NUREG-0847
Supplement No. 15

Safety Evaluation Report

related to the operation of
Watts Bar Nuclear Plant,
Units 1 and 2

Docket Nos. 50-390 and 50-391

Figure 6.1 Divider Barrier Seal

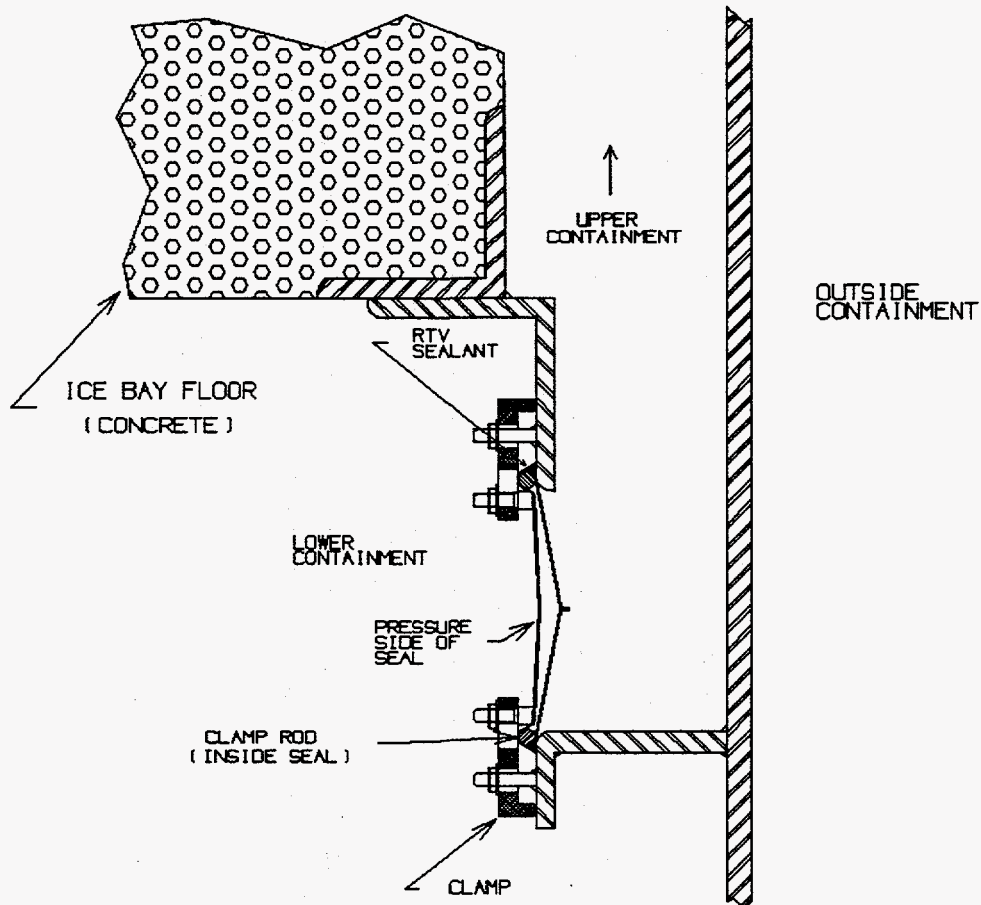
The cold-splice adhesive used in the installation of the material that replaces the removed specimens has been found to provide sufficient strength for LOCA integrity in the tested (unaged) conditions, but to be vulnerable to heat aging. As indicated above, its condition must, therefore, be monitored through additional unique periodic surveillance testing. Peel tests would be performed on test specimens at 18-month or 36-month intervals, the interval for each joint location being dependent on the initial peel test result for that location. The peel test procedure and recommended test intervals are described in Presray Report No. PR16550, "Procedure for Cold Bonding Divider Barrier Seal Splice Joints." The staff reviewed the report while on site on February 23, 1995. The test specimens are not part of the actual divider barrier seal. They are specimens of material removed during the repair and are located near the seal at each splice joint.

The staff reviewed the information submitted by the applicant and concluded that a revised divider barrier seal surveillance program is appropriate for Watts Bar Unit 1. The tensile testing may be deleted based on the additional testing that demonstrates that the seal material, including the original vulcanized joints, is qualified for a 40-year life and DBA-LOCA. Additional peel tests on test coupons will be performed periodically to monitor the condition of the adhesive used in the cold-bond/bolted splices. The test frequency for the peel tests will be as recommended by the vendor.
